LEXINGTON-FAYETTE URBAN COUNTY GOVERNMENT CONTRACT CHANGE ORDER Page 1 of 11		Date:	October 1, 2025
To (Contractor):		Project:	Clays Mill Road Improvements, Section 1
L-M Asphalt Partners, Ltd.		Location:	CMR - Waco to Harrodsburg
dba ATS Construction		Contract No.	17-2020
3009 Atkinson Ave, Suite 400, Lexington, KY 40509		Original Contract Amt.	\$10,683,653.39
		Cumulative Amount of Previous Change Orders	\$1,373,272.58
		Percent Change - Previous Change Orders	12.85%
		Total Contract Amount Prior to this Change Order	\$12,056,925.97
		Change Order No.	5 - Final
You are hereby requested to comply with the following changes from the contract plans and specification;			
Current Change Order

LEXINGTON-FAYETTE URBAN COUNTY GOVERNMENT CHANGE ORDER				DATE:		October 1, 2025
				Change Order #:		5 - Final
				CONTRACT #:		17-2020
Project: Clays Mill Road Improvements, Section 1						
You are hereby requested to comply with the following changes from the contract plans and specifications;

**Clays Mill Road Improvements, Section 1
Change Order No.5 - Final
Reasons for Porposed Changes**

1896 -1898 Clays Mill Road

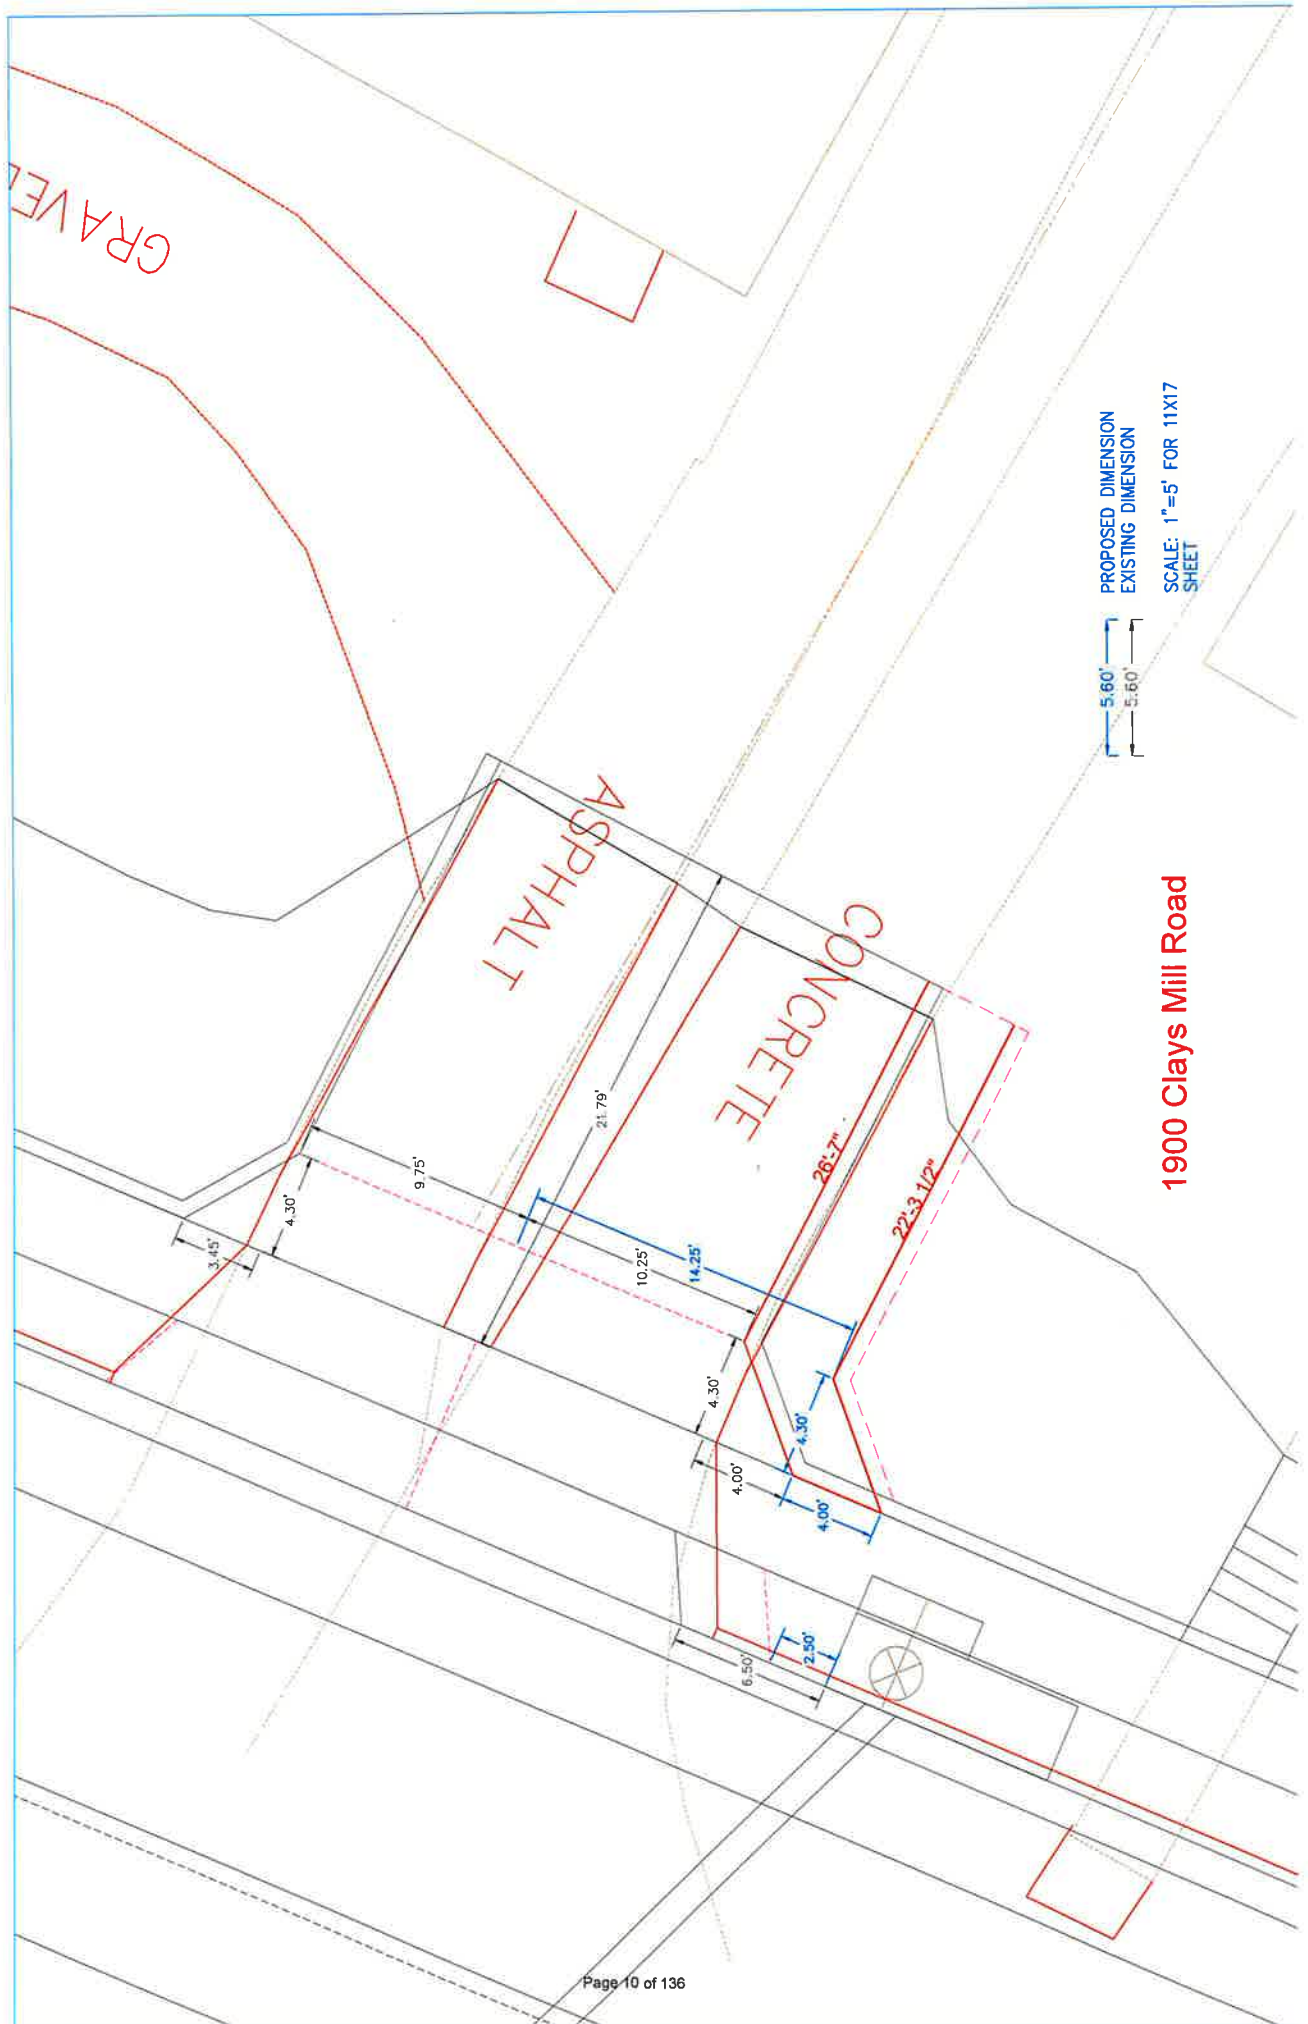
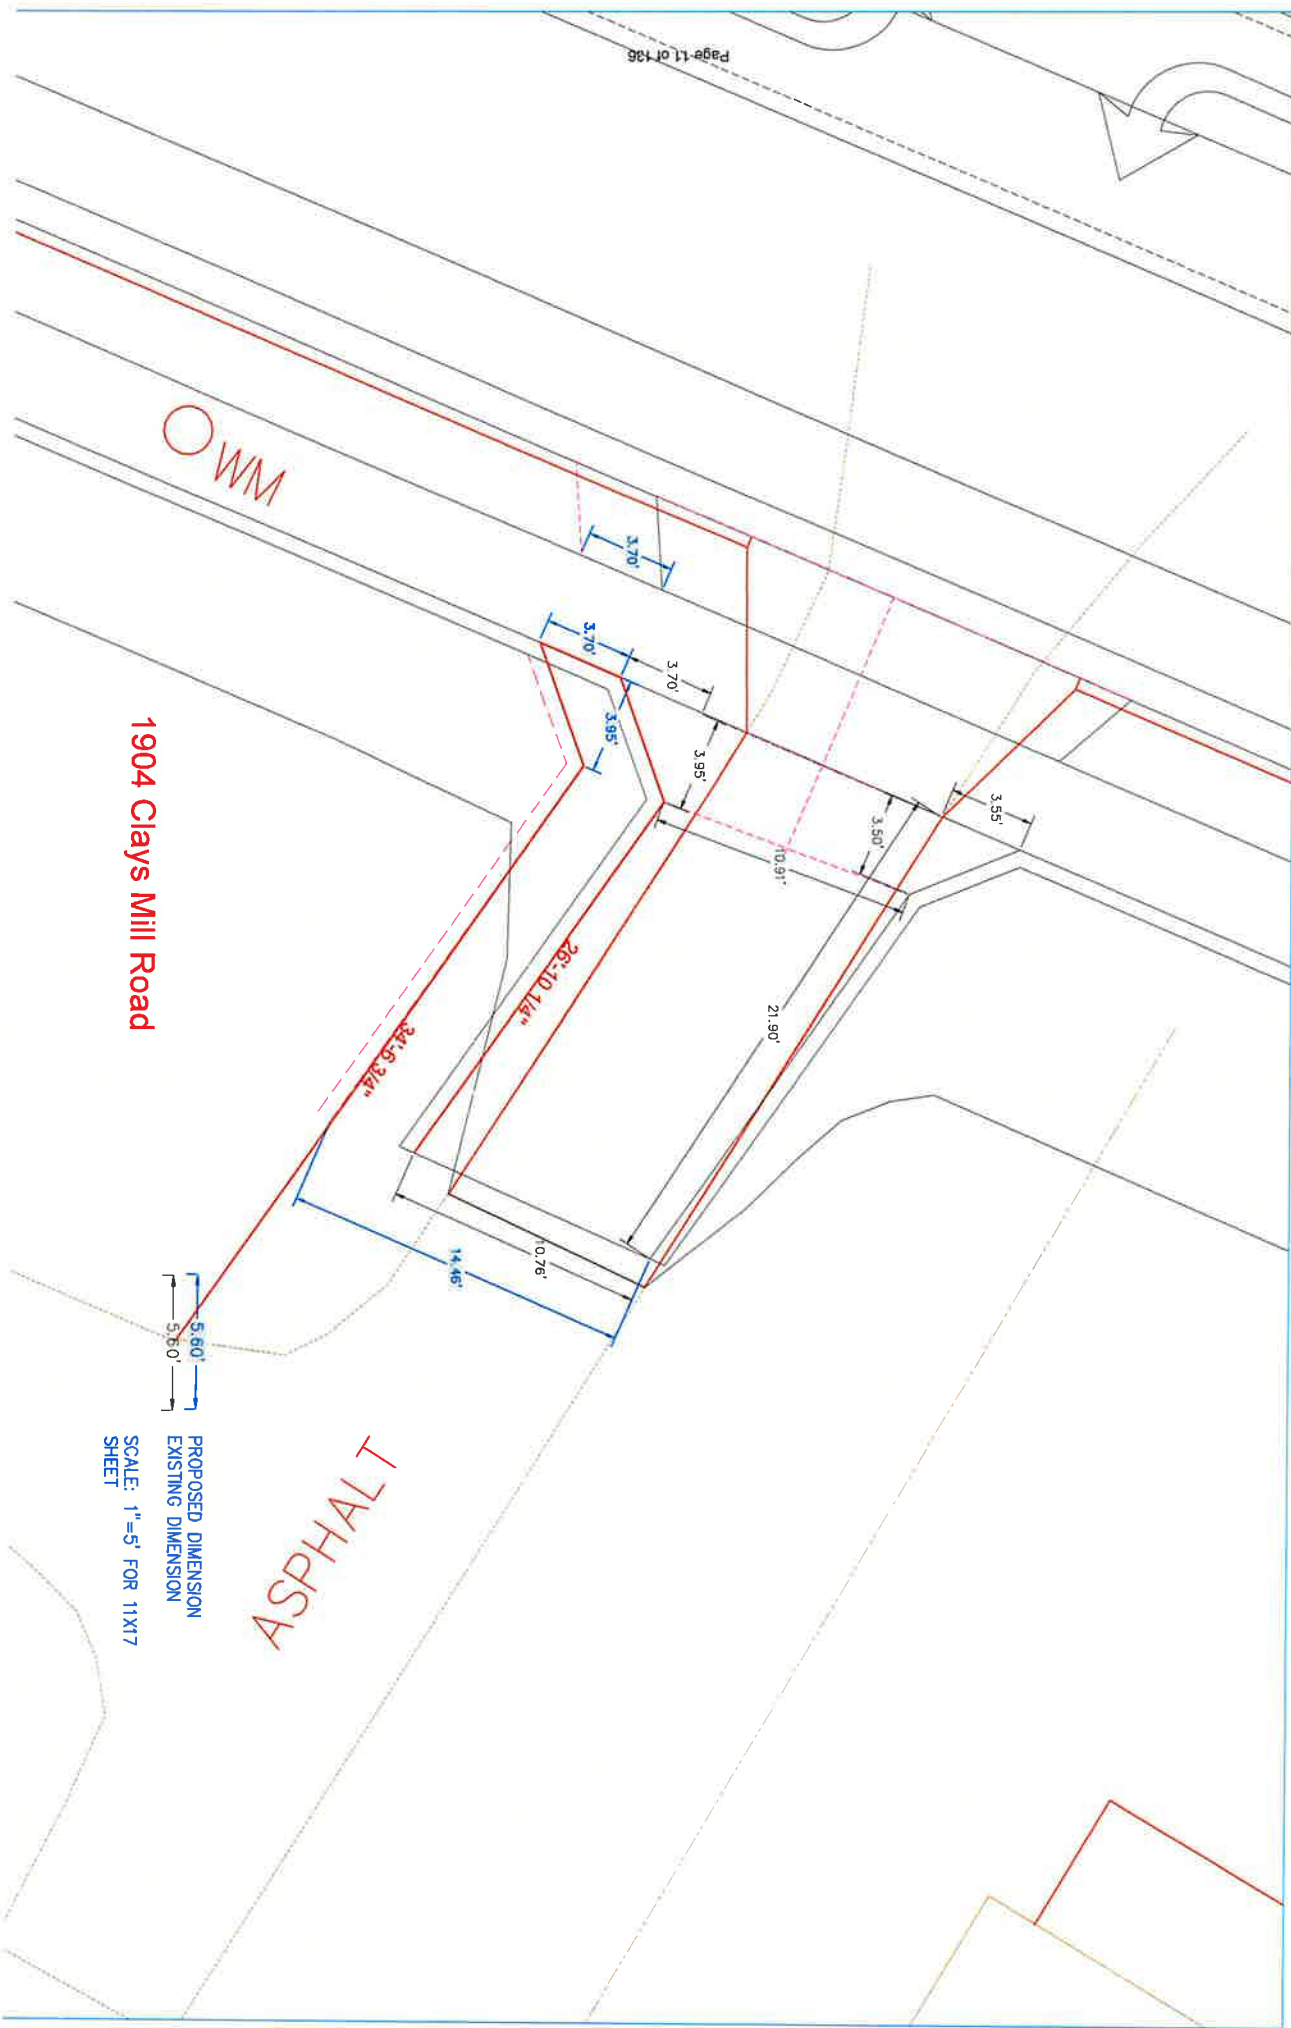
RE: Clays Mill Road Widening
BID NO. 17-2020
Added Retaining Wall Changes (Driveway Improvements)

ADDED Retaining Wall 142 LF @ \$425/LF = \$60,350

Clays Mill Road Lane Allen to Harrodsburg Closures

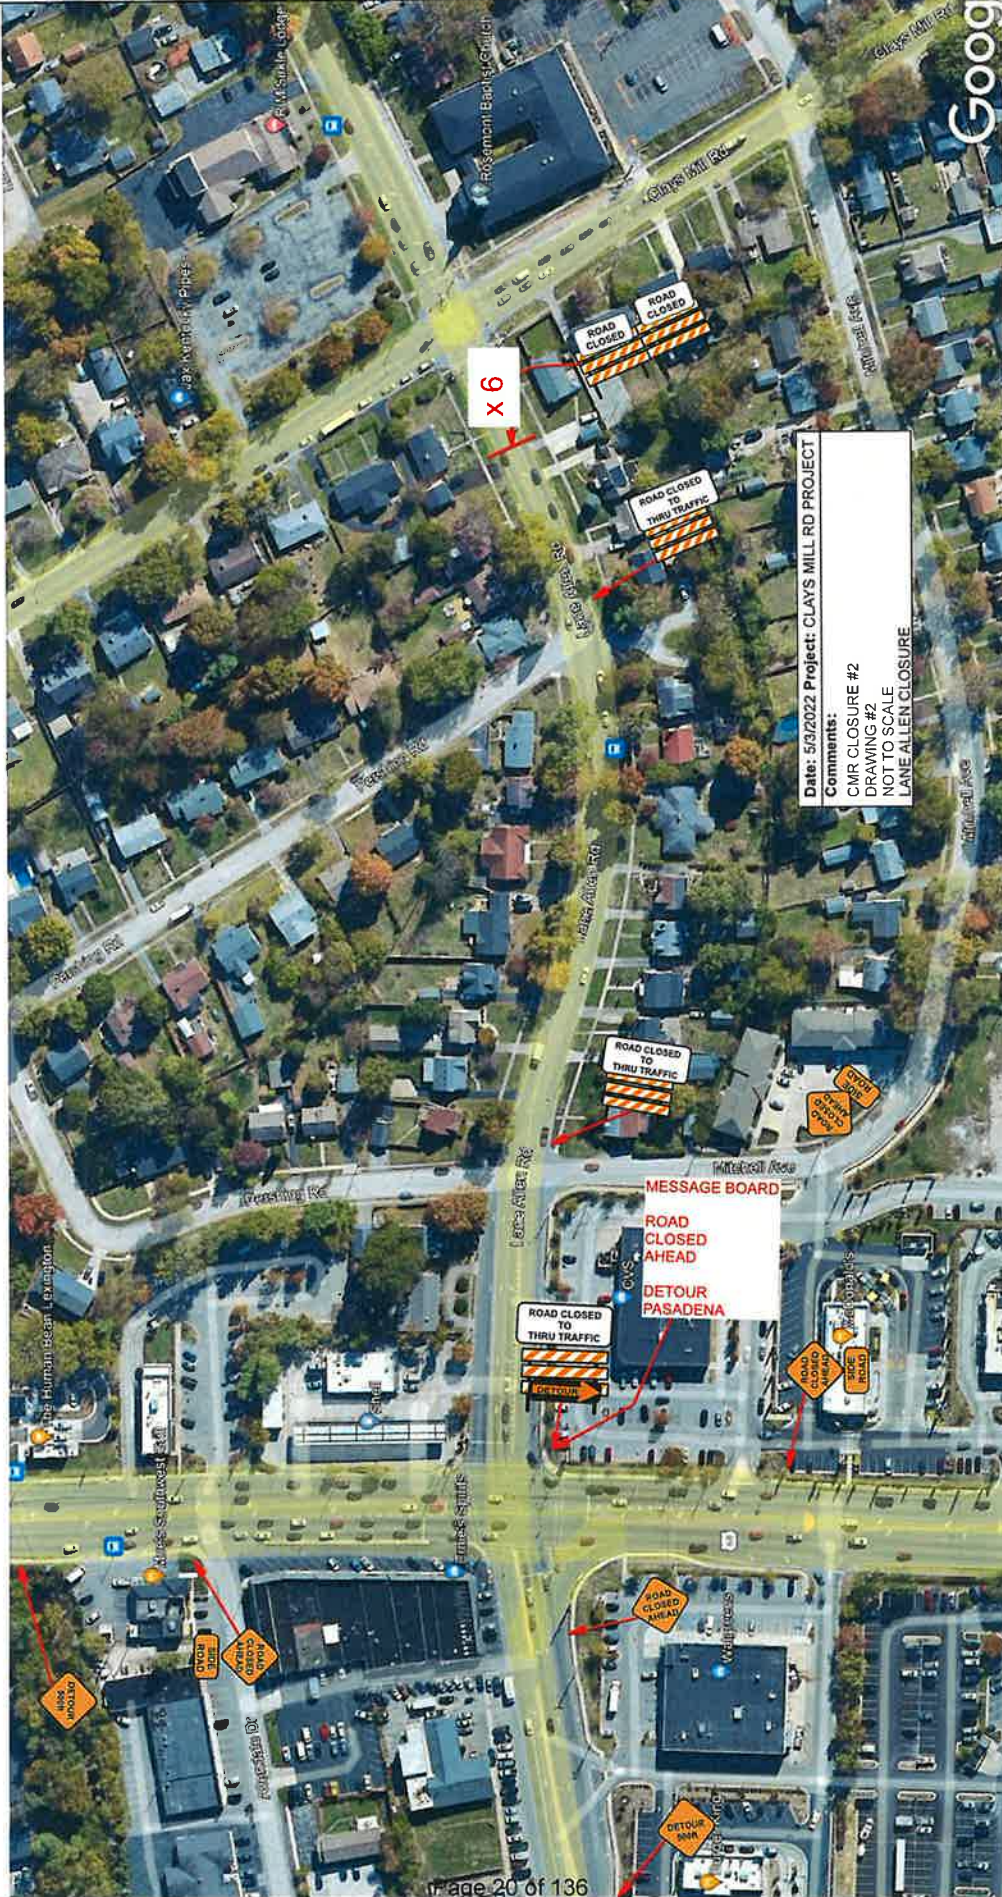
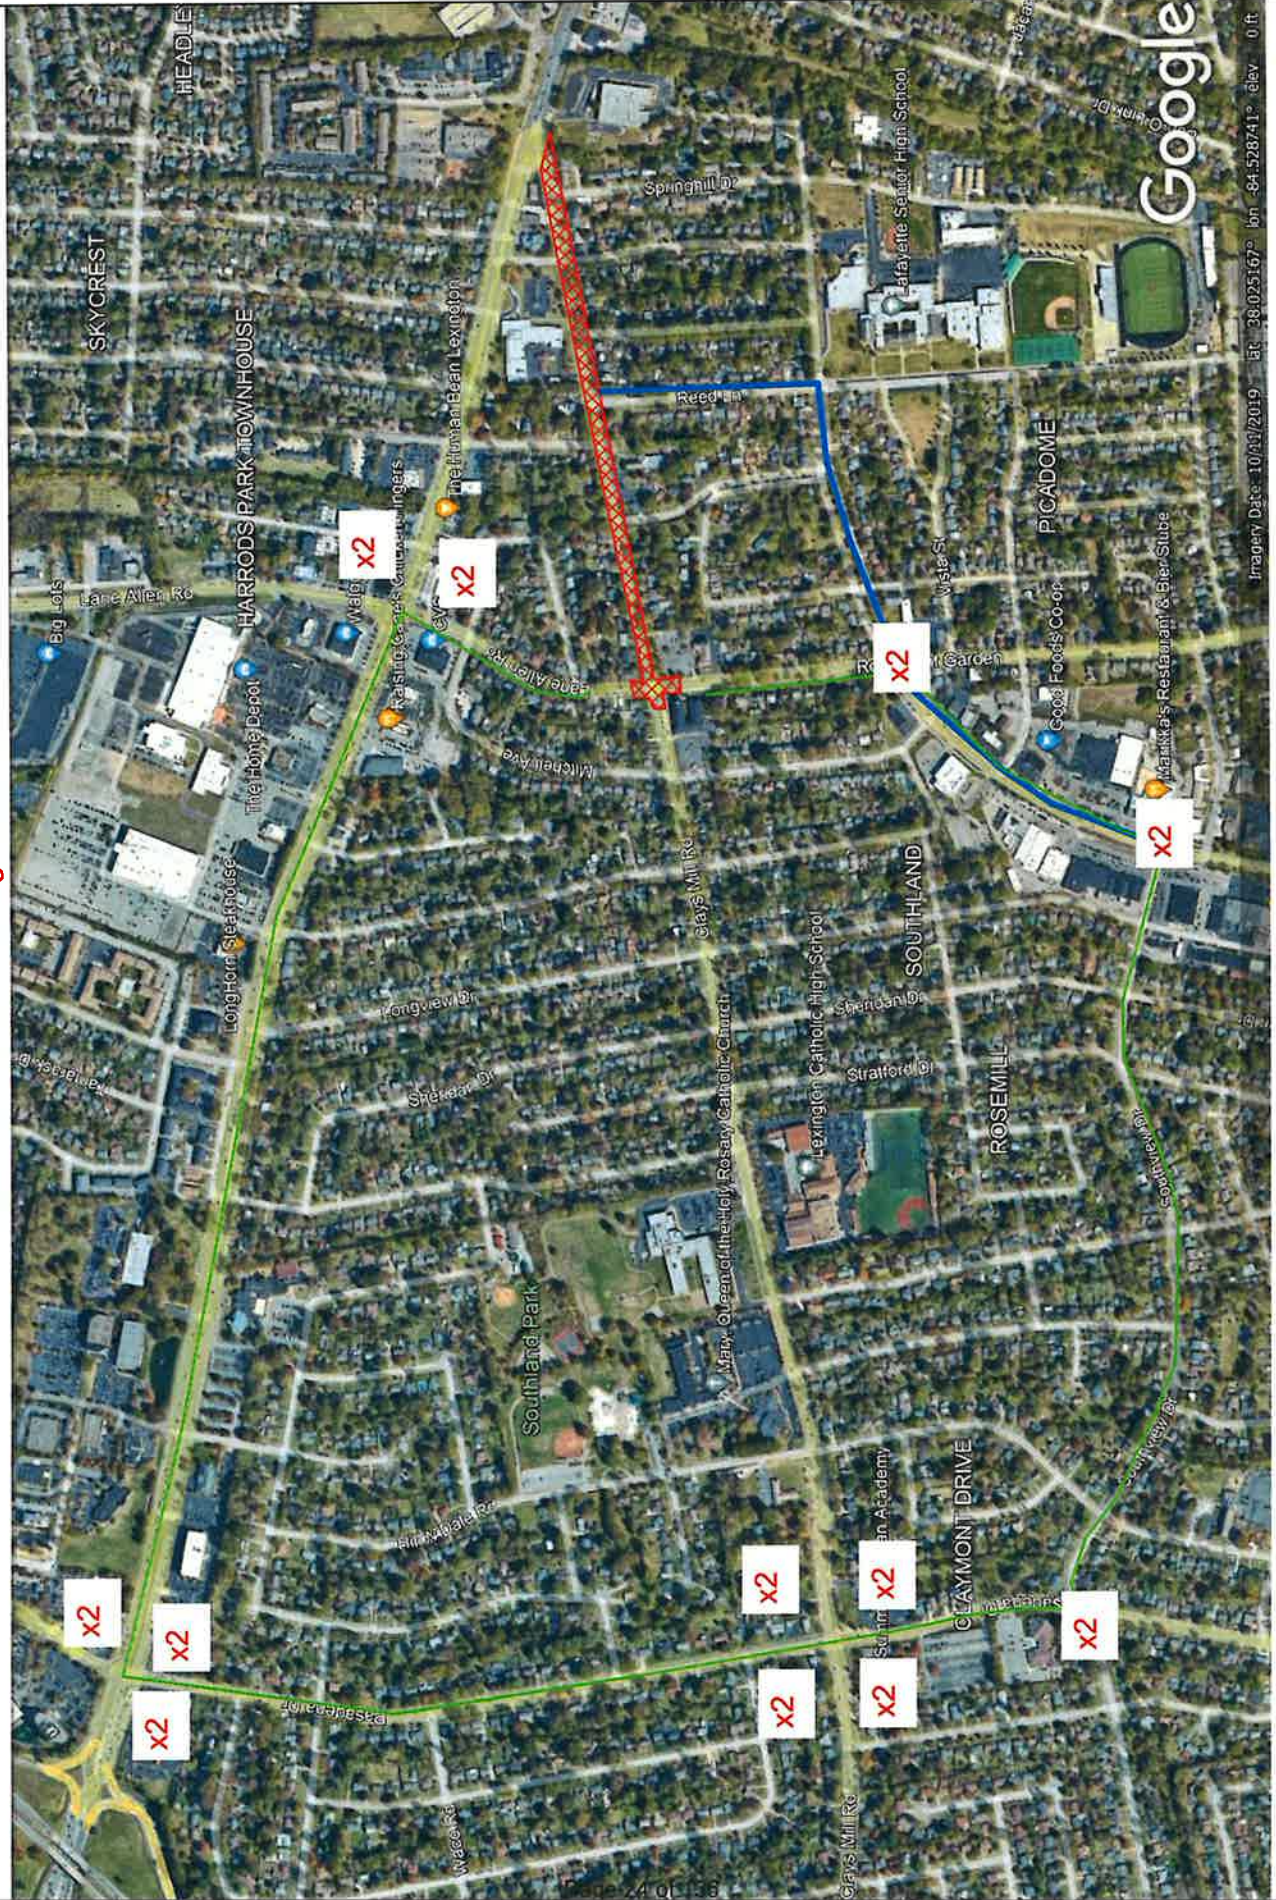
In a letter dated June 24, 2023 (attached), supplemental pricing was provided for the closure of the Clays Mill Road and Lane Allen intersection to complete both contractual work and utility relocations. This proposal has been modified based on the attached closure plan and summaries and includes subsequent closures to Harrodsburg Road.

Revised proposal below based on quantities of the attached closure plan.
